Options for relaxing the 800GBASE-ER1 optical frequency accuracy specification

IEEE P802.3dj

Supporting comment 389

July, 2025 Madrid, Spain

Table 187-5—800GBASE-ER1-20 and 800GBASE-ER1 transmit characteristics

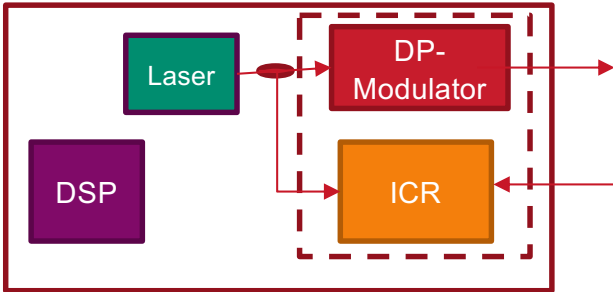
<i>Cl</i> 187	<i>SC</i> 187.6.1	<i>P</i> 638	<i>L</i> 27	# 389
Maniloff, Eric		Ciena		
<i>Comment Type</i>	T	<i>Comment Status</i>	D	<i>Optical) Coherent parameters</i>
The ± 1.8 GHz accuracy specification in Table 187-5 is required for DWDM applications, however is not required for single-wavelength applications such as 800GBASE-ER1. This accuracy can be loosened, and depending on other requirements can still be compatible with DWDM lasers. Loosening the optical frequency accuracy spec allows additional technologies to be used for 800GBASE-ER1				
<i>Suggested Remedy</i>				
Relax the accuracy spec in 800GBASE-ER1 to ± 20 GHz. A supporting contribution will be provided, showing the tradeoffs with different laser implementations.				
<i>Proposed Response</i>	<i>Response Status</i> W			
PROPOSED ACCEPT IN PRINCIPLE.				
Pending review of the following presentation and CRG discussion.				
<URL>/maniloff_3dj_xx_2507.pdf.

For single wavelength applications, the laser accuracy specs for DWDM applications aren't required, allowing migration to unlocked lasers

Changing the carrier frequency spec to $\pm 20\text{GHz}$ broadens the available components for 800GBASE-ER1

The carrier frequency accuracy of 800GBASE-ER1 can be loosened to $\pm 20\text{GHz}$ to allow a wider range of technical solutions

Shared Laser Solutions

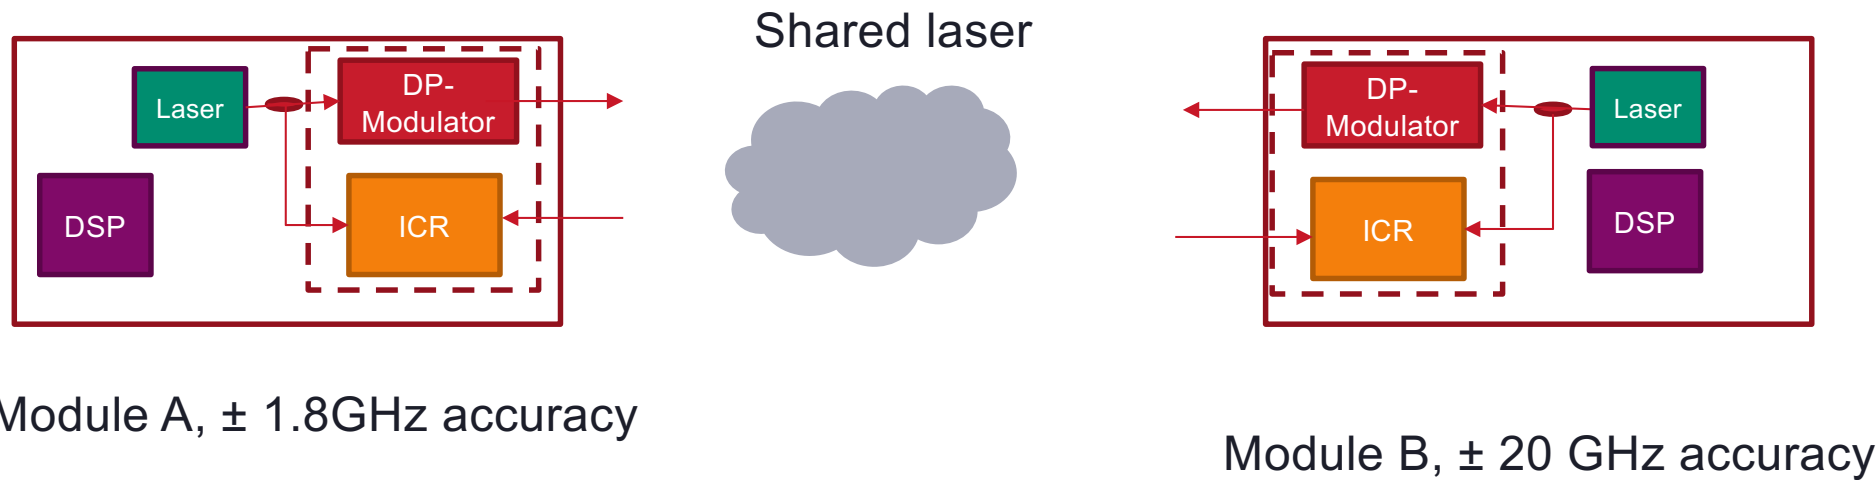
With a shared laser, both lasers will tune

The requirement for this to function is for each laser to have tuning range $\geq 2x$ its accuracy spec

Module B's tuning range allows interop, as B will tune to align the two ends' lasers

Mixed Solutions

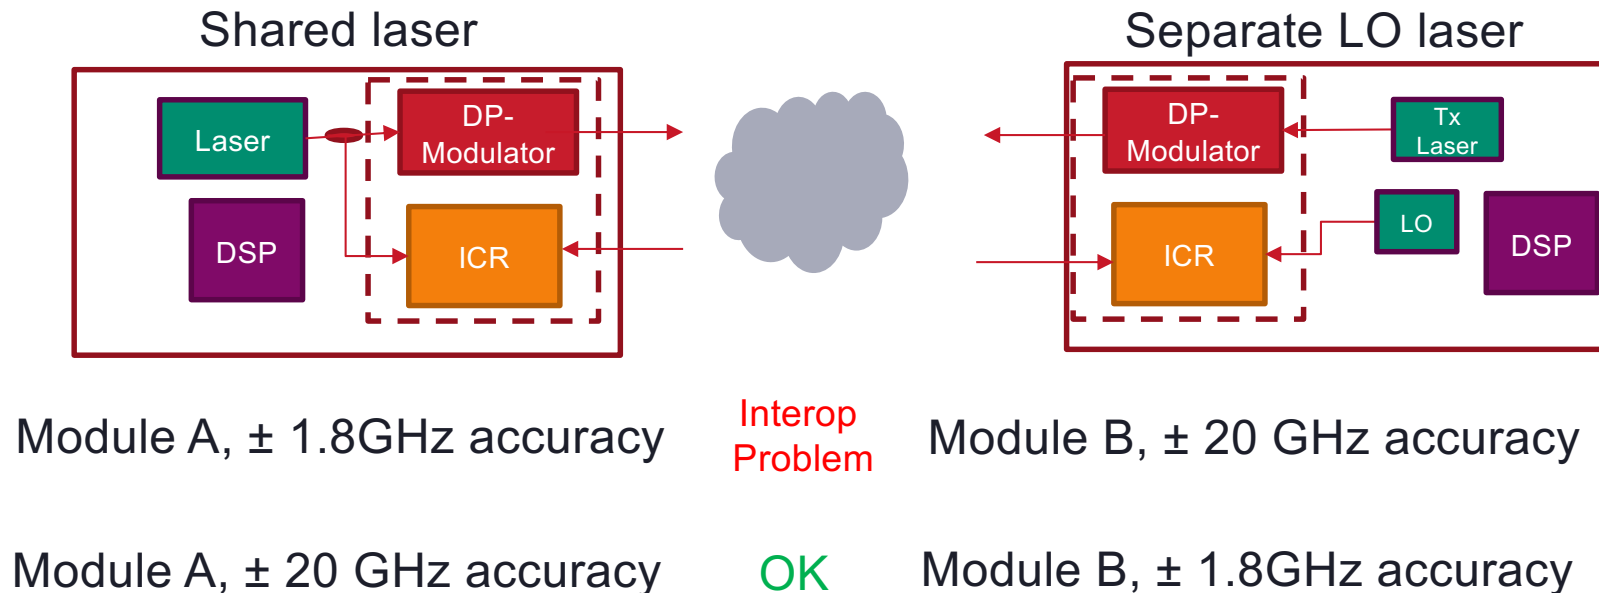
The LO tuning range must accommodate the worst-case Tx frequency inaccuracy

Since module B Tx does not tune, Module A Laser must have sufficient range to accommodate worst case frequency offset

- Support for single-laser solutions with a limited tuning range would be incompatible with dual-unlocked lasers.
- 800GBASE-ER1 can accommodate a looser accuracy spec, provided a shared laser is required
